Access Compliance Report

Public Rights-of-Way

Intersection ID: 13994	Main Street: E_3RD_ST	Cross Street: S_TORRENCE_ST	Location: SE
ADA ID: CA9A111C94A5	Ramp Type: Perp	Initial Pass/Fail: Fail	Overall Compliance: No
Severity Score: 8.75			
Codes/Mitigation Info/Possible Solution		Field Measurements/Component Compliance

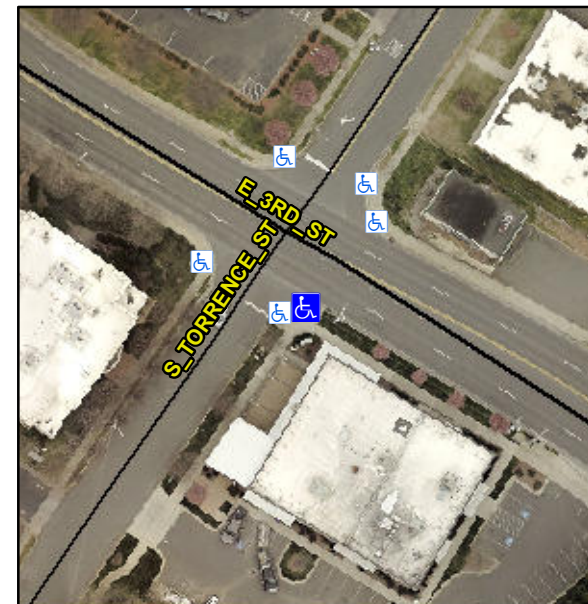
Not Found, R304.5.1

Remove & Replace Entire Ramp.
